DATE: December 23, 2024

ADDENDUM NO. 3

PROJECT NO. DGS C-0503-0027 PHASE 001
PROJECT TITLE - Danville State Hospital - Replace Steam Generation Equipment
PROFESSIONAL:

DRAWN BY Author	DATE 10-14-2024	SHEET No. A-2
CHECKED BY Checker	SCALE As indicated

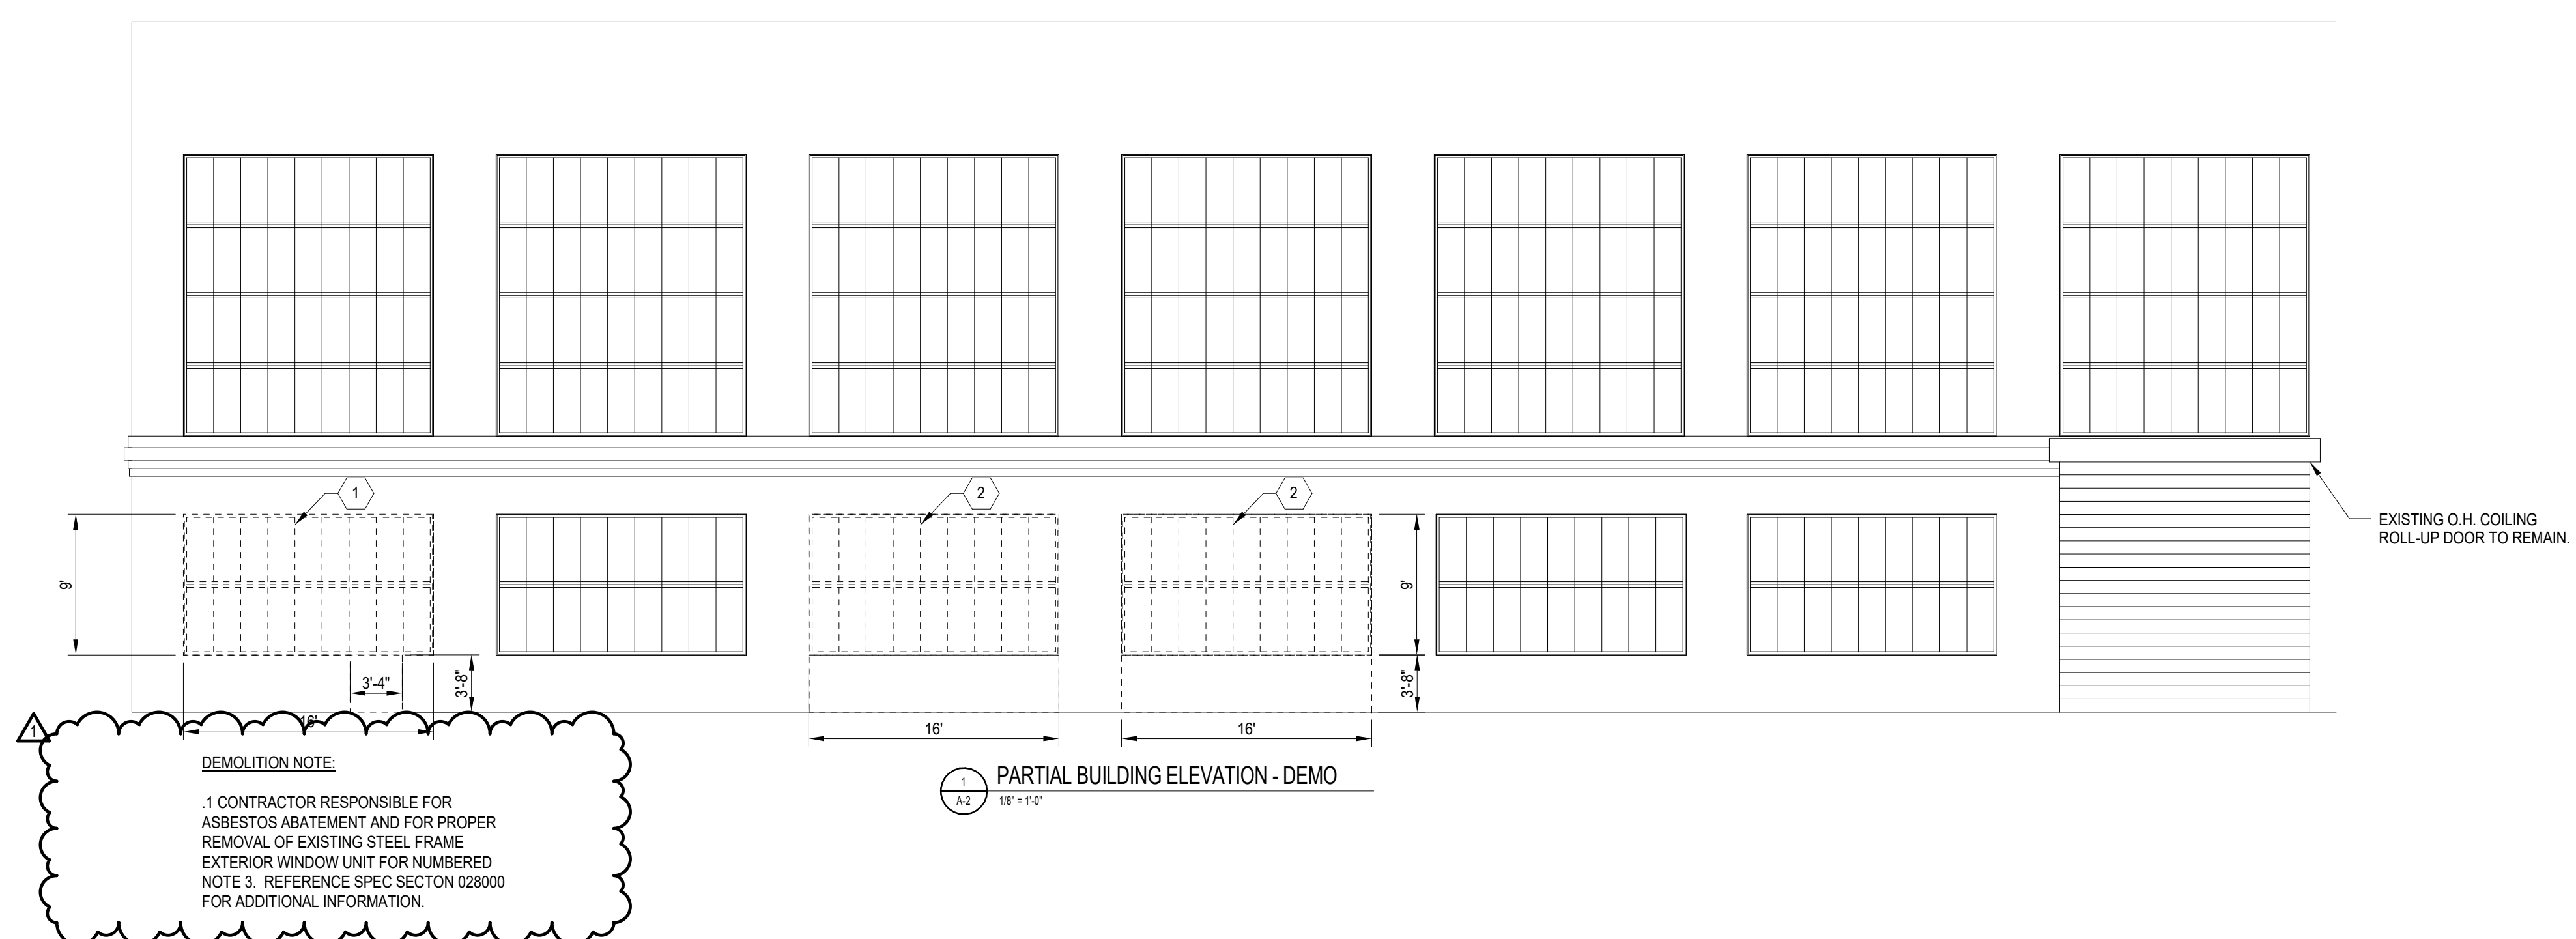
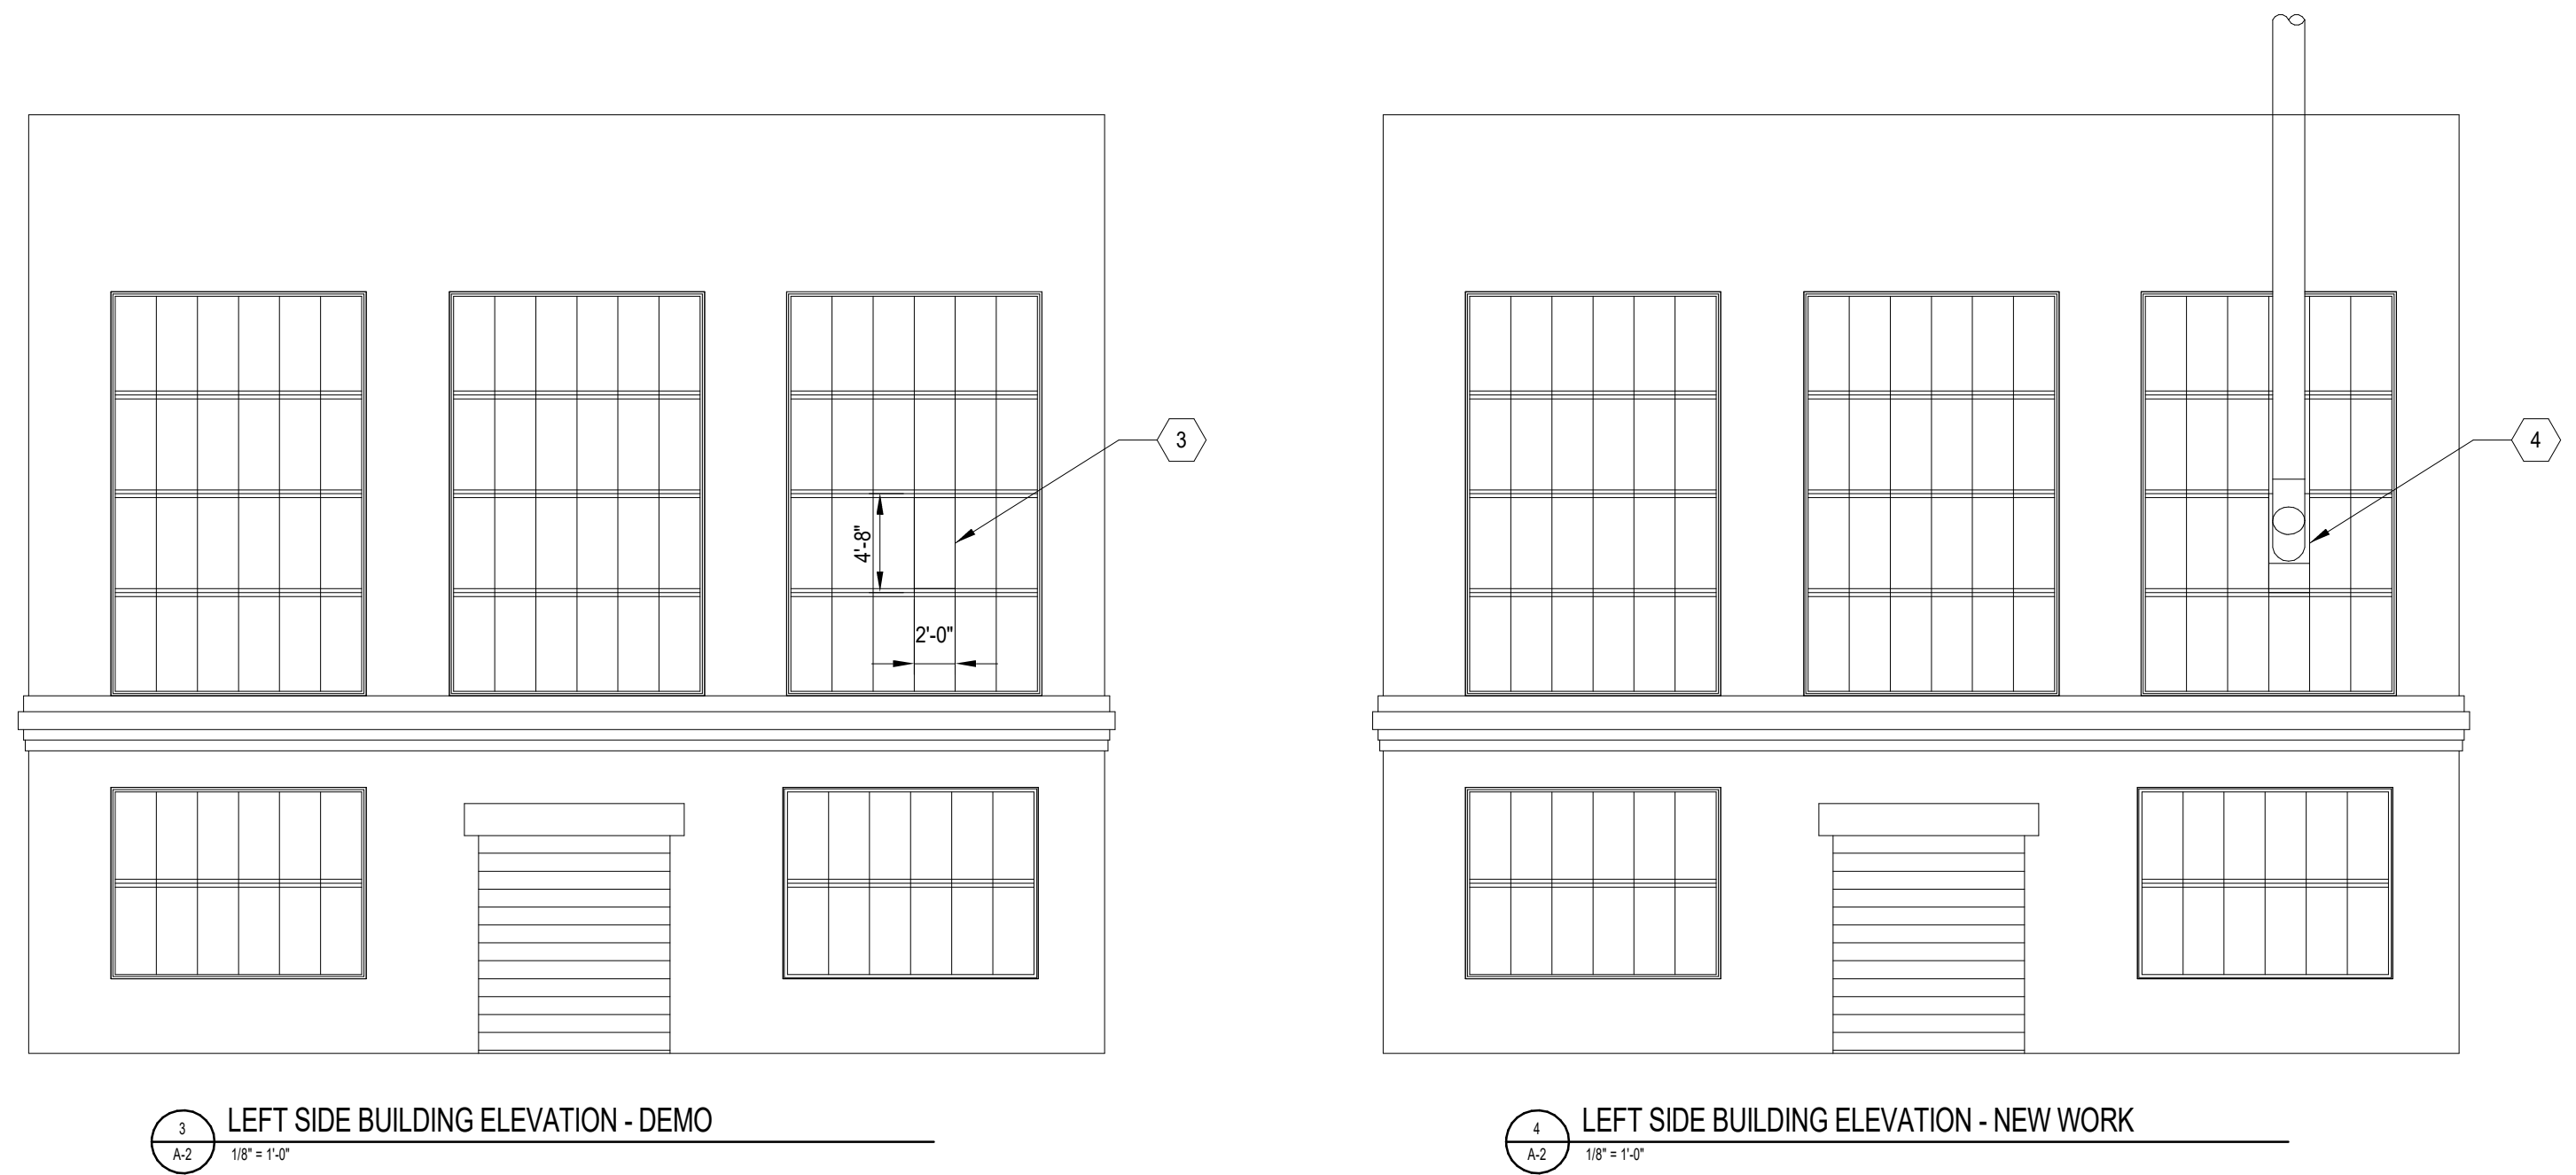
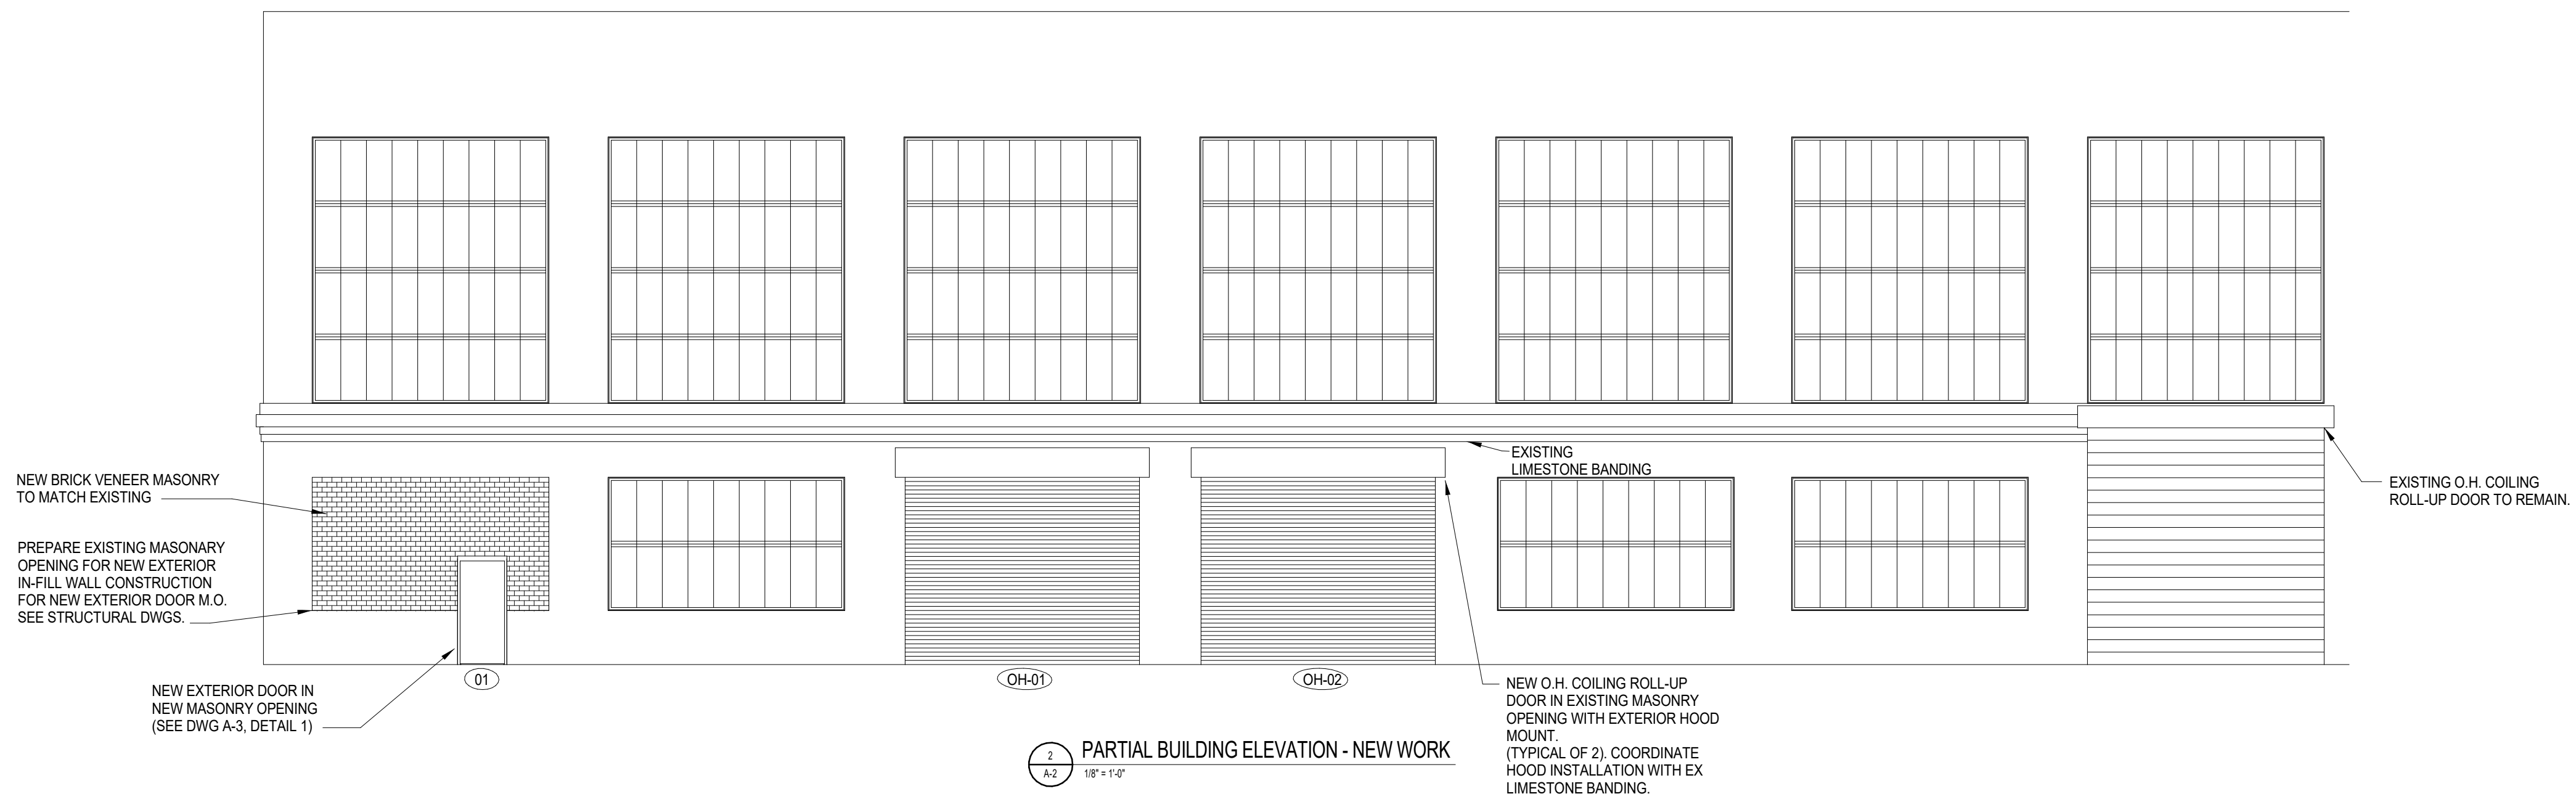
The facility is performing the demolition work to remove two sections of approx. 144 square feet of steel frame window for new overhead coiling door / frame assembly and one section of approx. 144 square feet of steel frame window for new man door / frame assembly as noted on drawing A-1 & 2. This portion of work is removed from the scope of the project. Drawings A-1 & 2 have been revised to indicate that this work is being performed by the facility. Specification Section 010100 – Summary of Work and 010300 – Base Bid Descriptions have been revised to remove wall demolitions.

The facility is performing the abatement of the windows being removed for the two new overhead coiling doors, man door, and existing piping insulation where new pipe is to connect to the existing piping mains. This portion of work is removed from the scope of the project. Drawings A-1 & 2 have been revised to indicate that this work is being performed by the facility.

- 1 CLIENT AGENCY IS TO REMOVE EXISTING APPROX 144 SQFT STEEL FRAME WINDOW UNIT COMPLETE. CLIENT AGENCY IS TO REMOVE PORTION OF EXISTING MASONRY WALL FOR NEW MAN DOOR / FRAME ASSEMBLY.
- 2 CLIENT AGENCY IS TO REMOVE EXISTING APPROX 144 SQFT STEEL FRAME WINDOW UNIT COMPLETE. CLIENT AGENCY IS TO REMOVE PORTION OF EXISTING MASONRY WALL FROM WINDOW SILL TO EXISTING FLOOR SLAB FOR NEW OVERHEAD COILING DOOR / FRAME ASSEMBLY.
- 3 REMOVE EXISTING MASONRY WALL FROM WINDOW SILL TO EXISTING FLOOR SLAB FOR EXISTING STEEL FRAMED WINDOW AT THE UPPER LEVEL WINDOW UNIT FOR NEW 18" Ø FLUE PIPE.
- 4 PREPARE EXISTING STEEL FRAME WINDOW OPENING AT THE UPPER LEVEL WINDOW FOR NEW FLUE PENETRATION PANEL. FURNISH AND INSTALL NEW METAL FRAME INSERT ASSEMBLY FOR NEW FLUE PANEL.

DEMOLITION NOTE:
 1. CONTRACTOR RESPONSIBLE FOR ASBESTOS ABATEMENT AND FOR PROPER REMOVAL OF EXISTING STEEL FRAME EXTERIOR WINDOW UNIT FOR NUMBERED NOTE 3. REFERENCE SPEC SECTION 028000 FOR ADDITIONAL INFORMATION.
